Docket Item # 13  
BAR CASE #2005-0288

BAR Meeting  
March 1, 2006

**ISSUE:** Concept approval of a 57-unit condominium building

**LOCATION:** 900 N. Washington St

**Figure 1** Proposed site plan

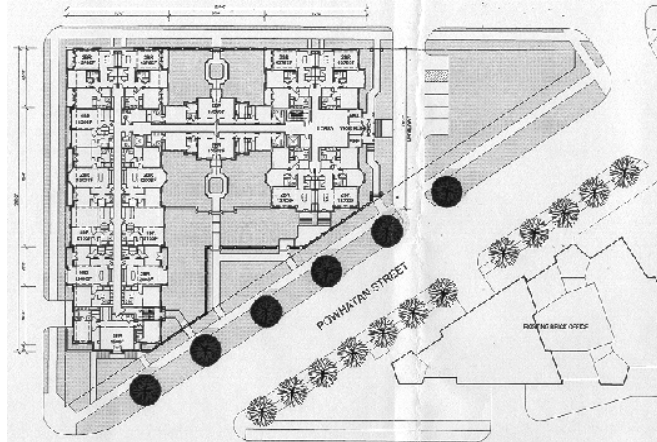
Due to the unusual triangular shape of the block on which the project is located, the applicant and Staff looked at the precedent set by the buildings that front North Washington Street and are bordered by Powhatan Street. The existing large open spaces off of Powhatan Street connected to the existing buildings that front North Washington Street helped to guide the decision to incorporate recessed green spaces on the project along Powhatan Street. In addition, this siting approach helps to mitigate the perceived mass and scale of the

project as viewed from North Washington Street and Powhatan Street. The project does maintain a street wall appearance along Montgomery Street, while a recessed open space area is incorporated on the North Columbus Street elevation.
